Lutak Dock Replacement

A Life Cycle Cost Analysis

Eben Sargent Feb 21 2024

Project Risks: Piledriving

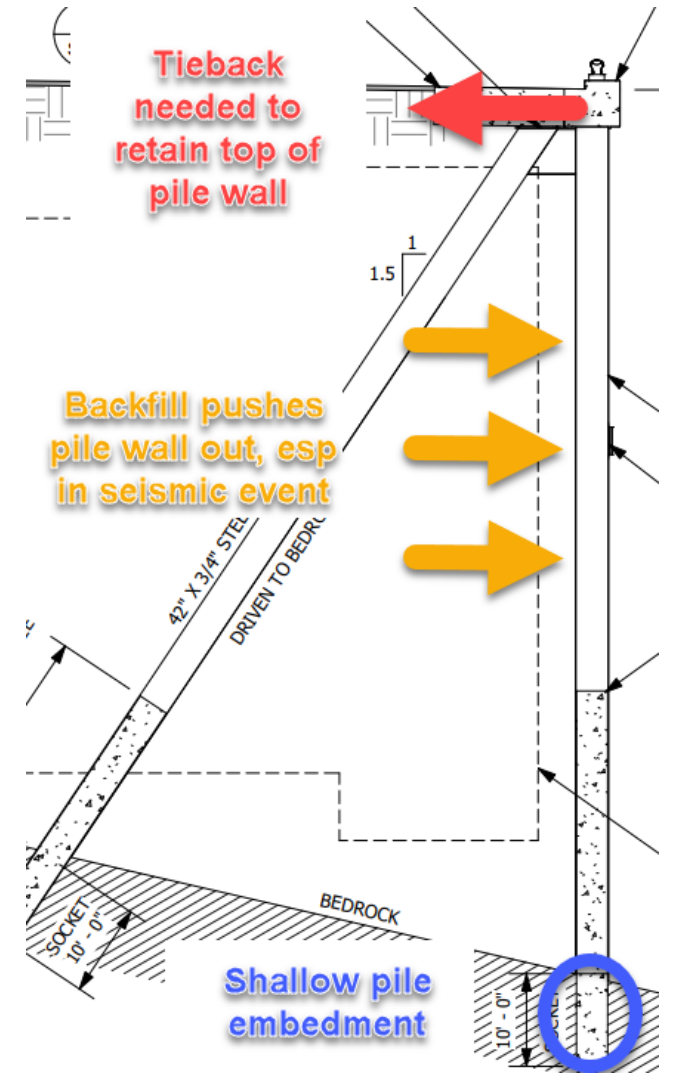
- RFP responses from all 3 firms cited geotechnical conditions as a prime project risk
- The Army solved this problem with self supporting circular cells that don't require tieback. Encapsulating these failing cells with a new wall downslope requires taller piles retained against outward forces
- The Rip Rap design of RAISE Grant award uses a pile wall half the height, half the width, further inland, with virgin backfill to reduce pile driving risk, along with other low risk elements such as rock bank armor and freestanding dolphins similar to ferry dock and AML RORO

35% design: Small horizontal tiebacks in every pile, up high above old dock cells

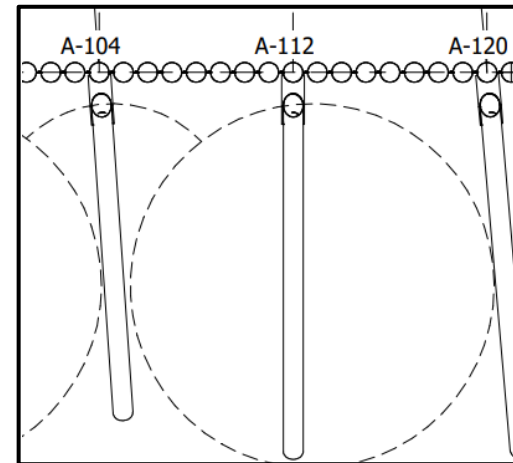
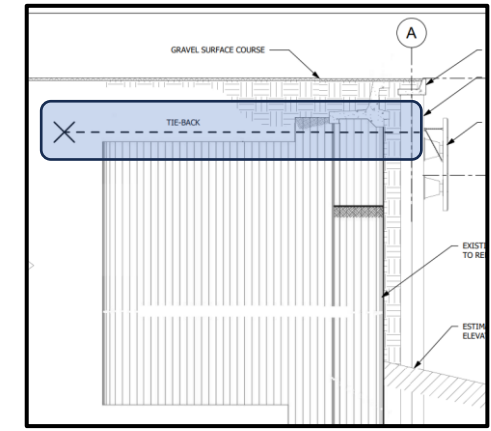
- The TMC encapsulate design is a prototype of a novel concept for rehabbing failing bulkhead docks that has not been widely implemented
- The Haines Borough cannot afford to develop new techniques. Typically the design phase is rosy and problems are found once dirt starts moving. This is magnified with new ideas. Ask yourself if contractor relations in this pre construction phase could be described as “rosy”
- The prototype nature of this design can be seen in the major change to critical tieback elements between 35% and 65% designs. Each of these designs have significant advantages and disadvantages that cannot be evaluated until dock has been constructed and in service for many years.

Project Risks: Steel price fluctuation

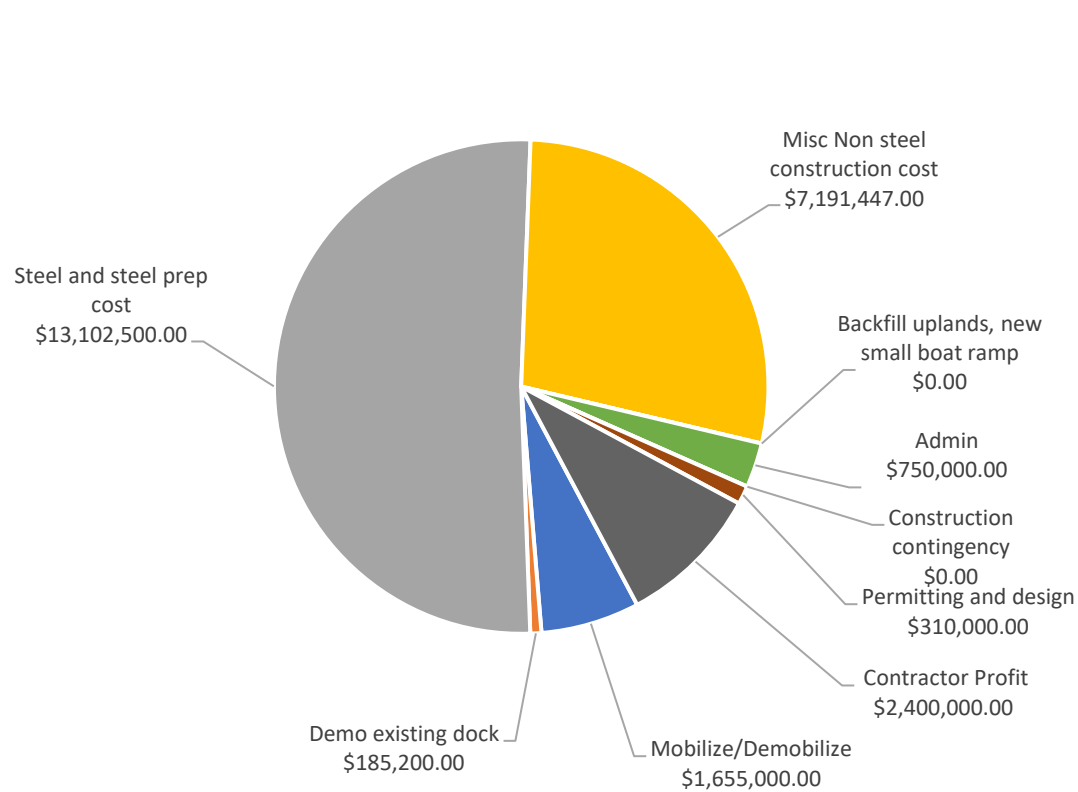
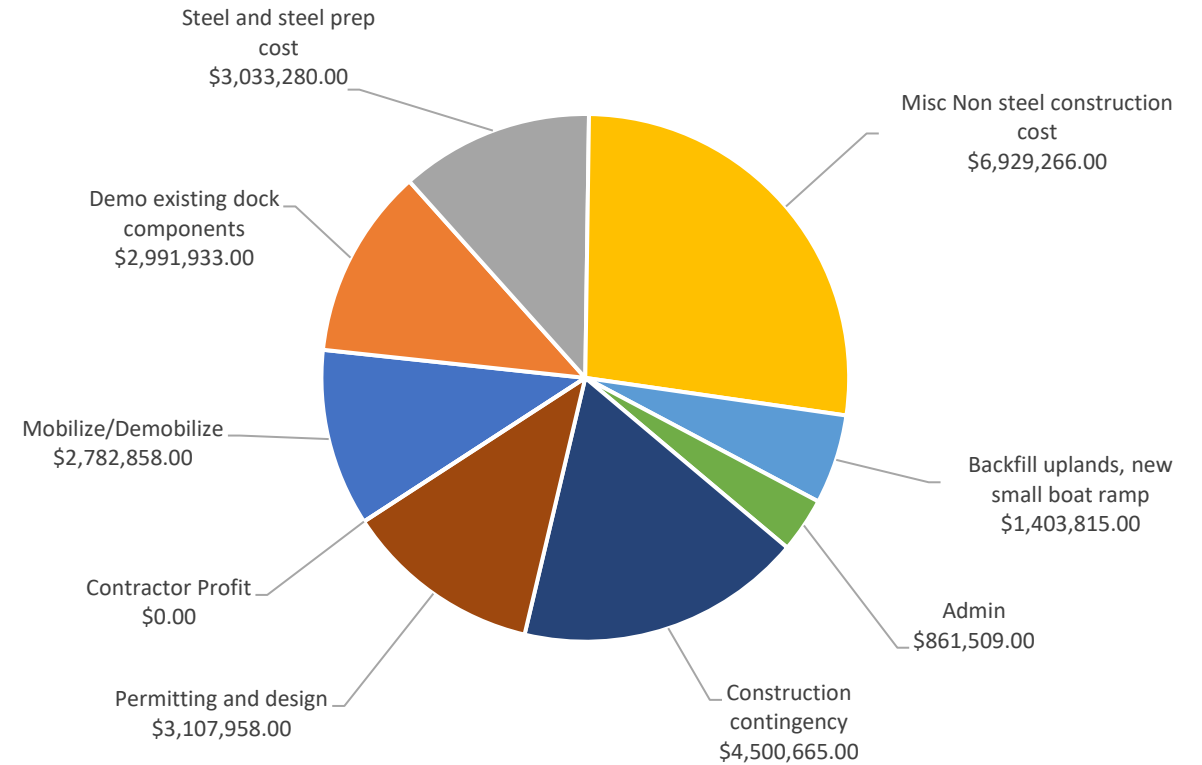
- Option 1 costs highly linked to steel prices – steel order costs less than \$13M million increase contractor profits, steel prices over 13M decrease contractor profits

Project Risks: Steel price fluctuation

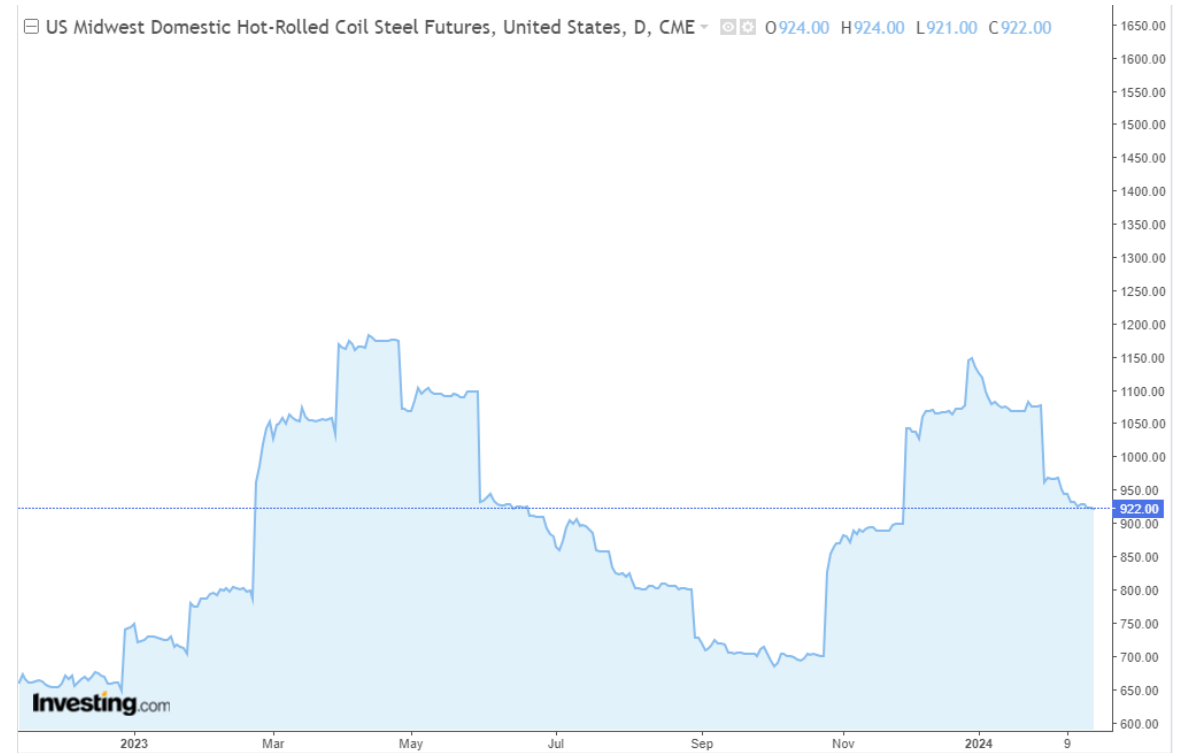
- Linking contractor profits to steel prices creates an incentive to order when prices are good despite other project impacts
- A steel price dominated budget leads to cuts in other areas, notably the TMC design phase at \$310,000 vs competitors design bids of \$685,000 and \$1,900,000 or the RAISE Grant estimate of \$3,100,000 by R&M

Hot Rolled steel coil prices have varied by almost 2X over the past year...
